City of Mississauga Department Comments

File(s): A484.21 Ward: 1

Property Address: 1559 Blanefield Road

The application proposes the construction of two accessory structures (sheds) requiring variances related to setbacks and gross floor areas of the accessory structures.

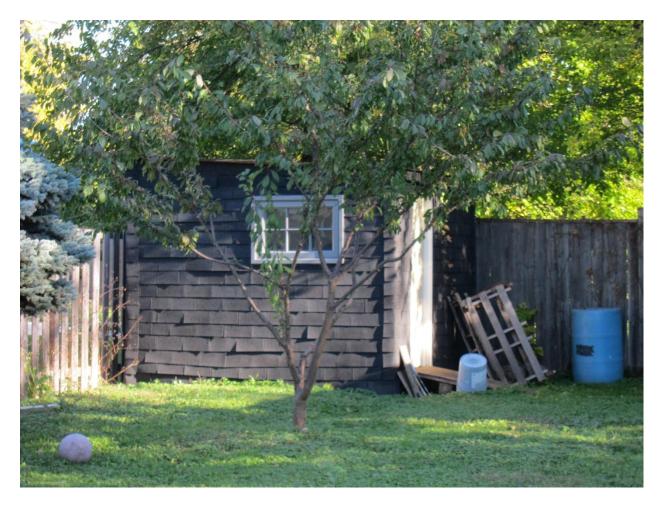
Enclosed for Committees easy reference are photos depicting the existing rear yard of the property including an existing shed. Should Committee see merit in the applicant's request, we ask that the new shed be equipped with an eaves trough and down spout directed in such a manor to not impact the adjacent properties.

Should Committee see merit in the applicant's request, we ask that the new shed be equipped with an eaves trough and down spout directed in such a manor to not impact the adjacent properties.
